MATERIAL CHANGE OF USE HEALTH CARE SERVICES – 5 PYNE STREET, EDGE HILL – DIVISION 7

PROPOSAL: MATERIAL CHANGE OF USE FOR HEALTH CARE SERVICES

LOCATION OF SITE: 5 PYNE STREET, EDGE HILL

That Council approves the development application for a Material Change of Use for Health Care Services (Dental Practice) over land located at 5 Pyne Street, Edge Hill, described as Lot 20 on RP702060, subject to the following:

1 SITE PLAN - PROPOSED
SCALE - 1 : 200

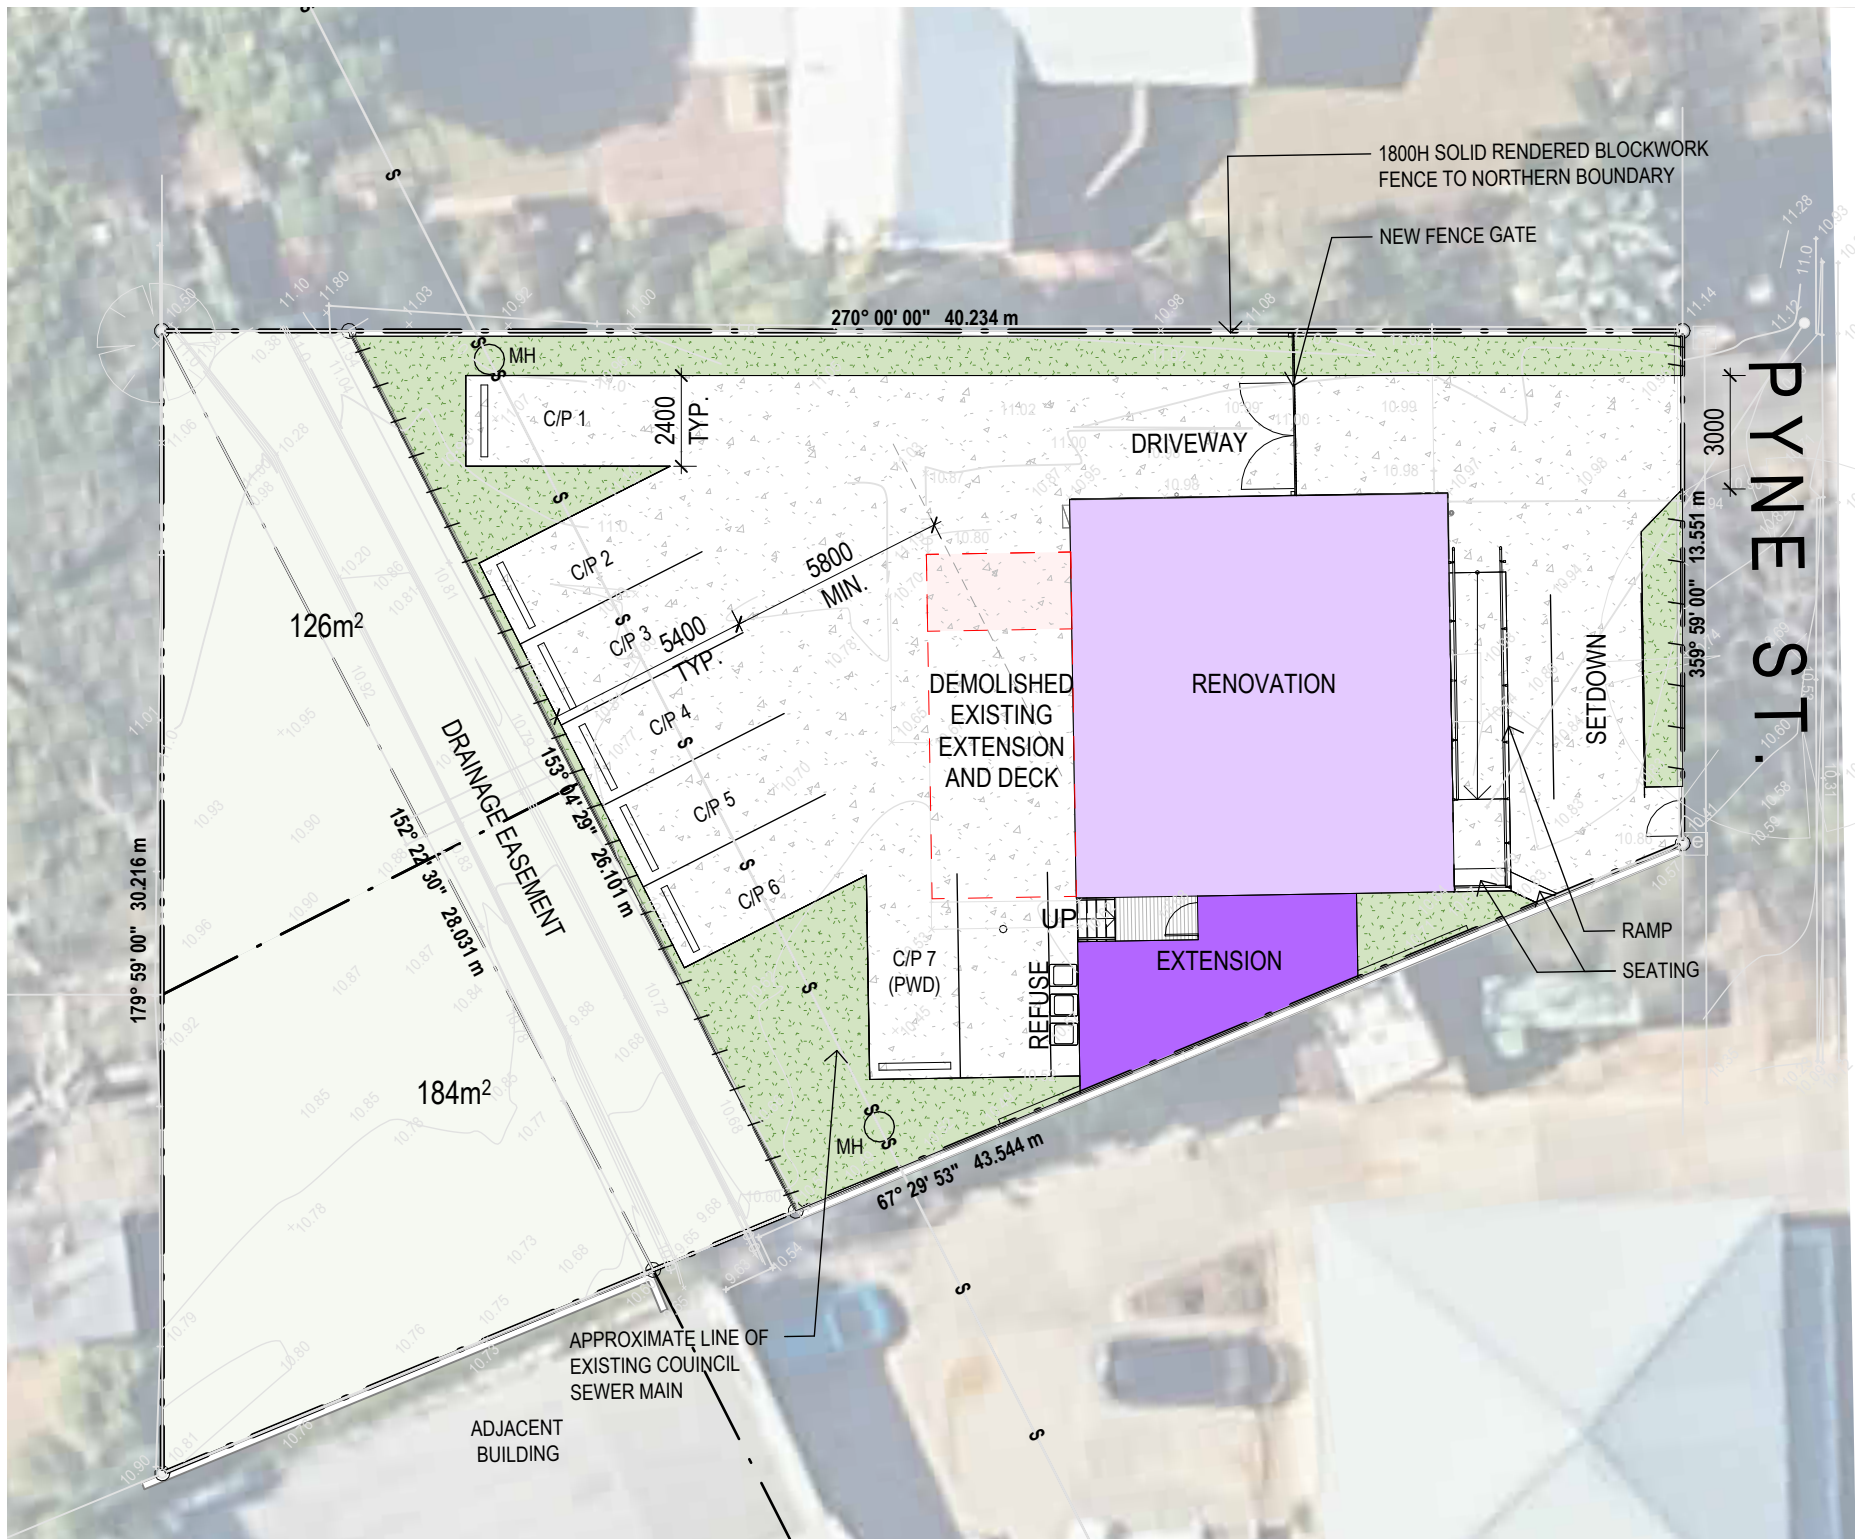
11.	Fencing a. Minimum 1.8m high solid screen fencing must be erected along the side boundaries of the development site from the road frontage to the eastern boundary of Easement A on RP734054 and for the length of the eastern boundary of Easement A on RP734054. b. Any proposed fence and/or wall to the street frontage must include a minimum 2m wide pedestrian entry gate as shown by the Approved Plans and is to be limited to the following: i. 1.2m in height if solid; or ii. 1.5m in height if at least 50% visually transparent; or iii. 1.8m in height if >50% visually transparent.	Prior to Commencement of Use.

16.	Footpath a. A minimum 2-metre-wide footpath must be provided, extending from where the existing concrete footpath terminates at the south-eastern corner of the development site, to a point past the proposed pedestrian entry gate shown by the Approved Plans. b. The footpath must be designed and constructed in accordance with FNQROC Development Manual (Version 9) Standard Drawing 1035 Pathways / Bikeways. This new section of footpath must match neatly to the existing footpath in alignment and grade.	Prior to Commencement of Use.

19.	Parking Signage Place signs at the frontage of the land advising the location of off-street parking.	Prior to Commencement of Use.
20.	Car Parking Requirements a. The amount of car parking must be as per the approved plan(s), being seven (7) spaces, inclusive of one (1) PWD. b. No reliance must be placed on on-street parking to meet any parking demand generated by the development. c. The car parking layout must comply with the AS 2890.1:2004 Parking facilities – Off-street car parking and be constructed in accordance with Austroads and good engineering design. d. The disability off-street car parking must be designed in accordance with AS 2890.6:2009 Parking facilities, Part 6: Off-Street parking for people with disabilities, including parking bay dimensions and shared area. e. The vehicle access and parking design must be approved by a suitably qualified RPEQ Engineer. f. All on-site parking, driveway and vehicular manoeuvring areas must be imperviously sealed, drained and line marked and must be provided with an exposed aggregate surface treatment (or similar) to the satisfaction of Council's delegated officer.	Prior to Commencement of Use.

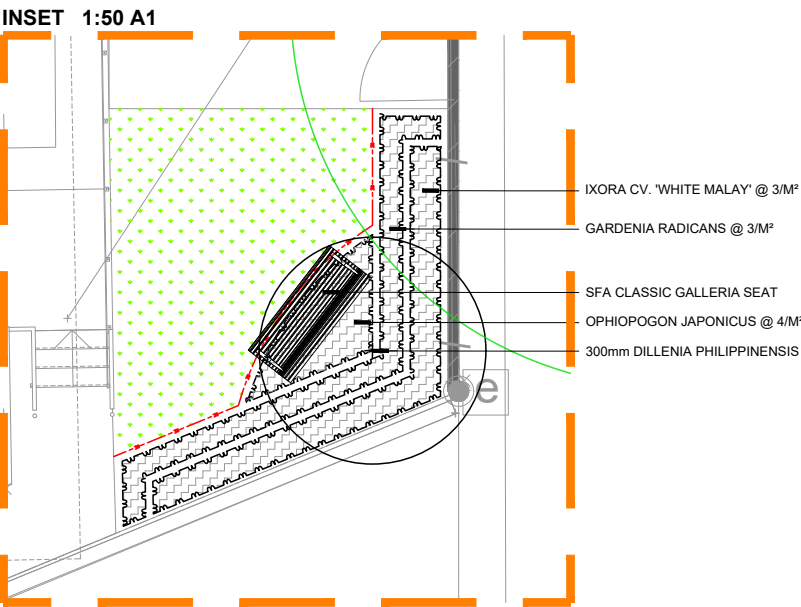
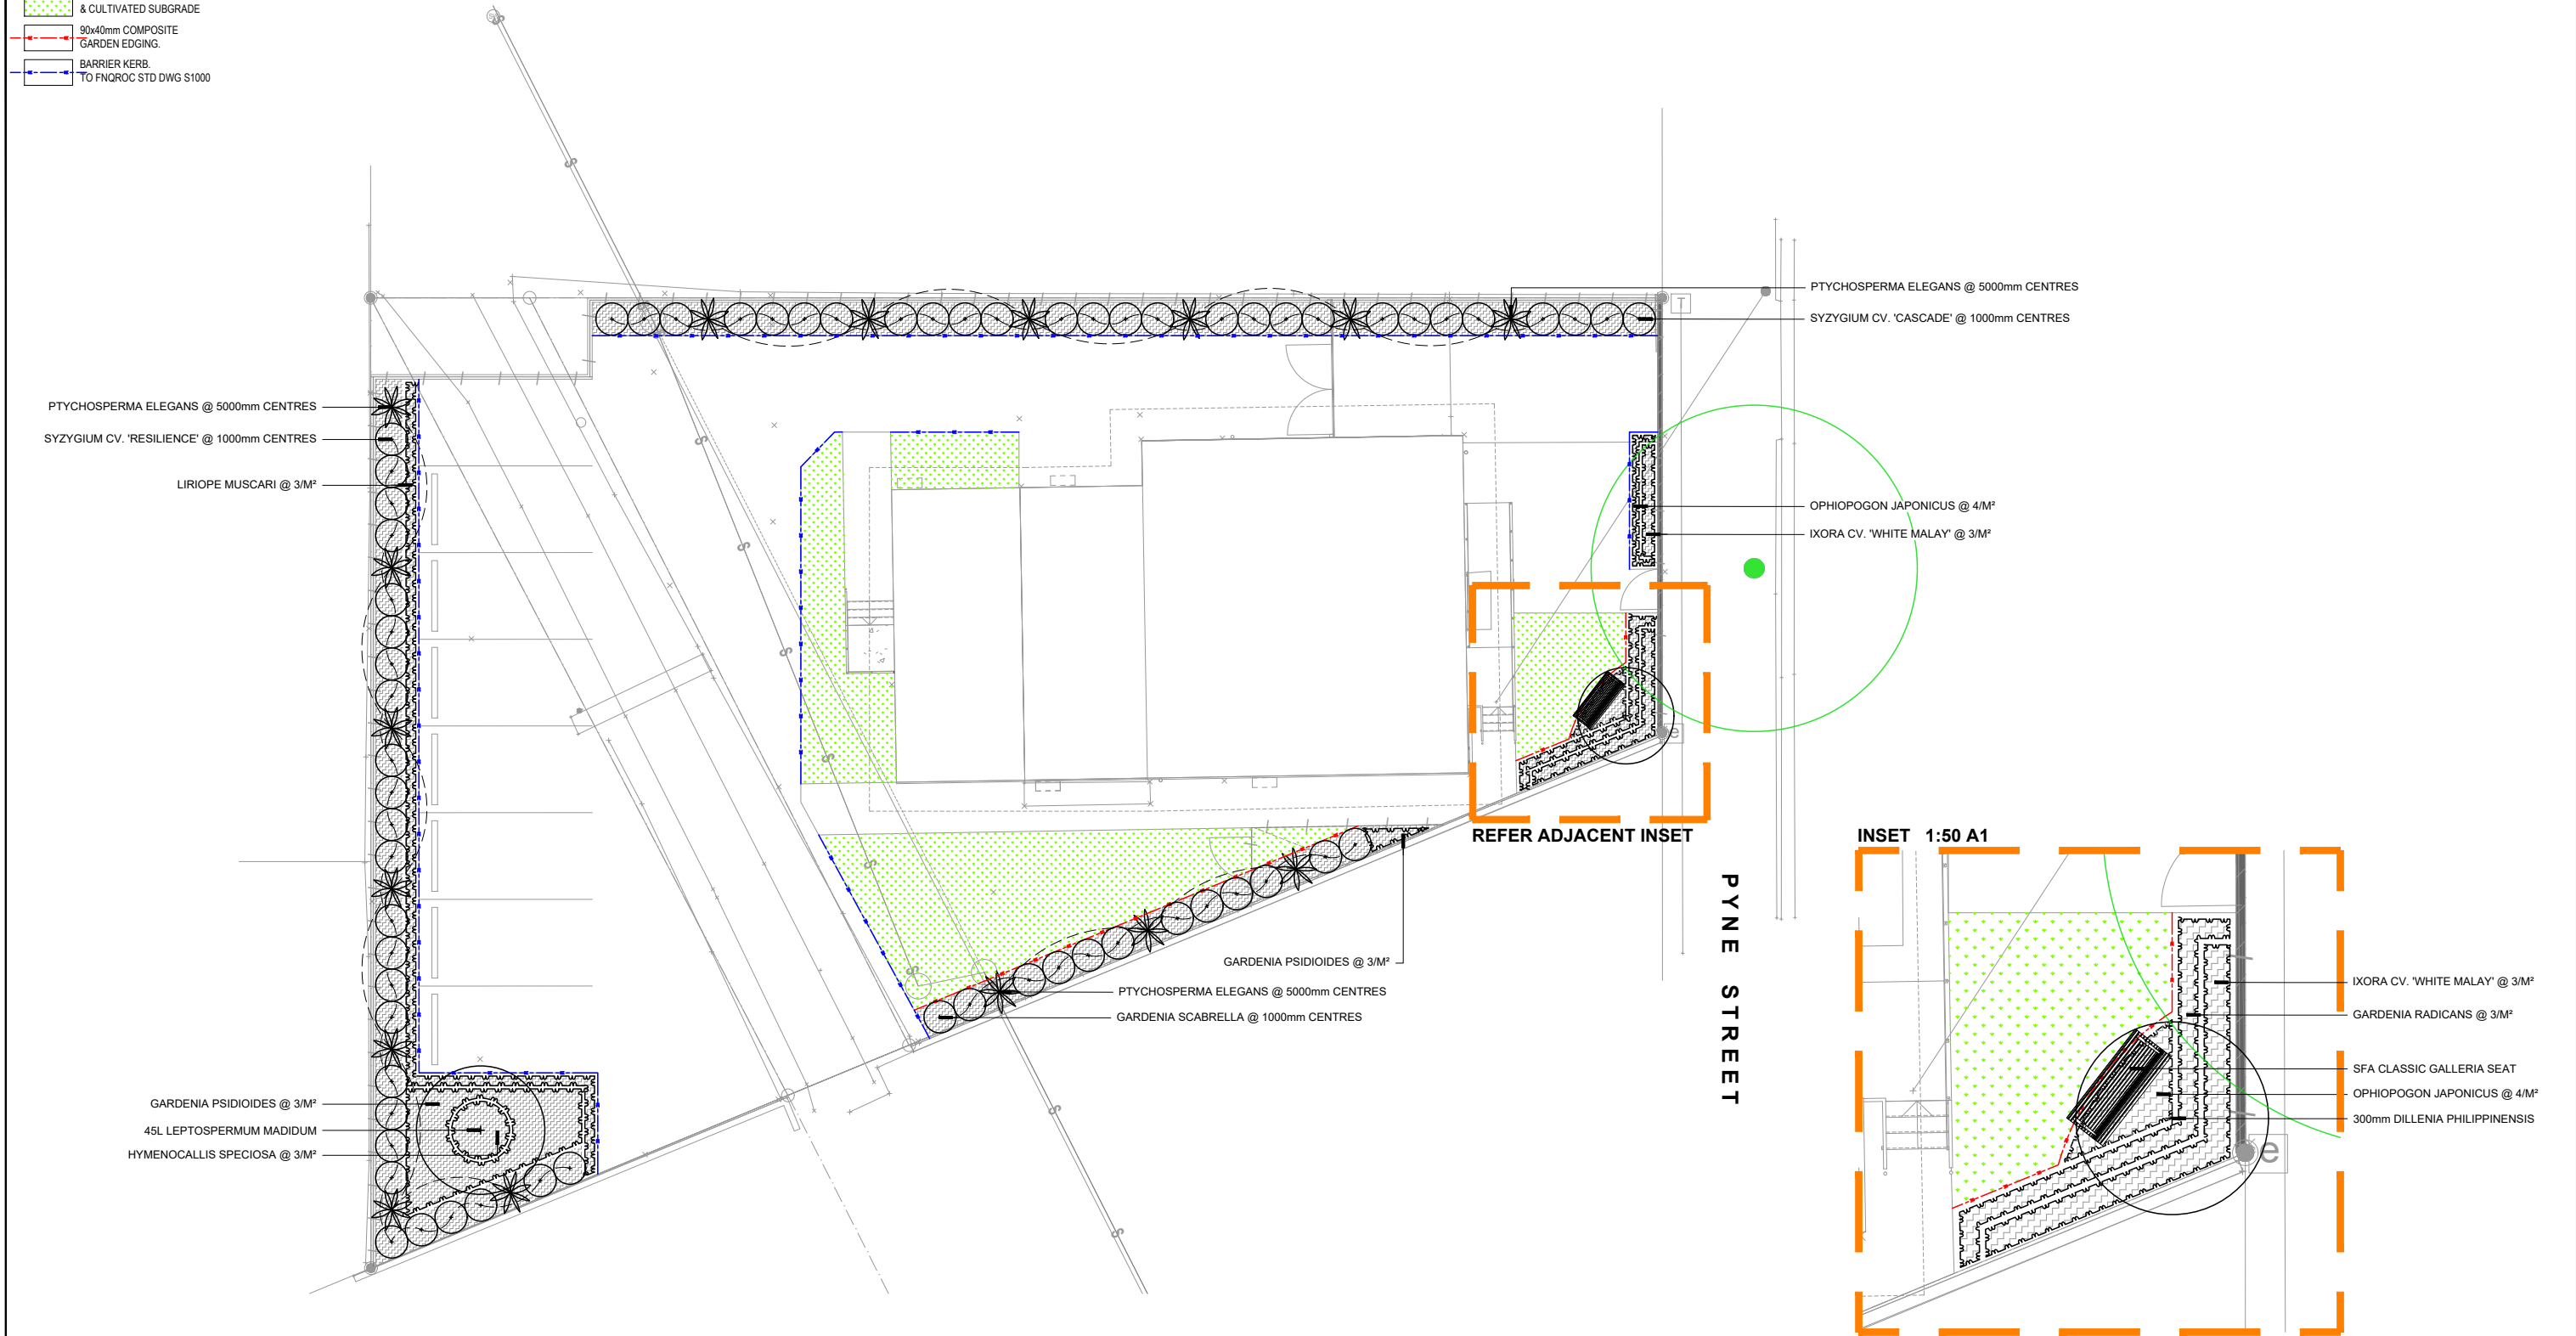
12.	Amended Landscape Plans Provide amended Landscape Plans for endorsement (LandPlan Drawing Numbers 2406-041-SD L1.01, Revision 01 and L2.01 Revision 01, dated 18 July 2024) in accordance with the following requirements: a. Reflecting the approved Site Plan (Clarke & Prince Drawing No. 1607-PD - A-20, Issue B, dated 6 November 2024). b. Planting Schedule: i. Botanic names and common names; ii. Quantities for supply and densities; and iii. Container supply size in accordance with the minimum supply size requirements within the FNQROC Development Manual (Version 9) Landscaping Specifications S8.06 Plant Stock. c. Specifications: i. Edging treatments; ii. Grassing; iii. Soil preparation; iv. Planting; v. Mulching; vi. Watering; and vii. Details of maintenance monitoring, and establishment. d. Amended planting design with a mixture of trees and large shrubs replacing the groundcovers, low shrubs and solitary palms between the centre activity, associated car parking and any adjacent residential use or zone. <i>Note: Officers are not supportive of the proposed cultivar Syzygium 'Cascade'. Syzygium 'Cascade' develops issues with branch die back from 4 years maturity within the Council LGA.</i> <i>The FNQROC Development Manual Cairns Regional Council Specific Plant Lists have a list of tree and tropical plant species found in the Local Government Area that are suitable for landscaping. Please use this (FNQROC Design Guidelines).</i>	Prior to Commencement of Landscaping Work.
